Twingo

X06

FRONT WIPER MOTOR

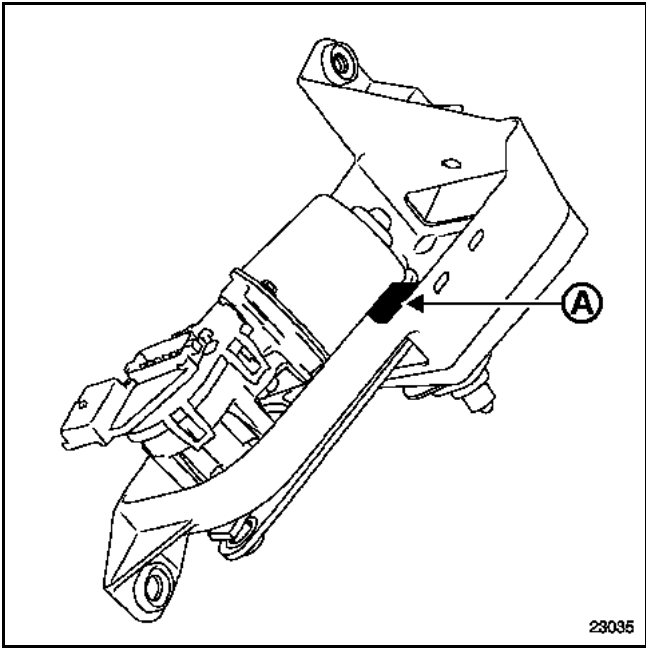
Due to modifications to the front wiper motor, it is now necessary to remove section (A) of the mounting when replacing the motor.
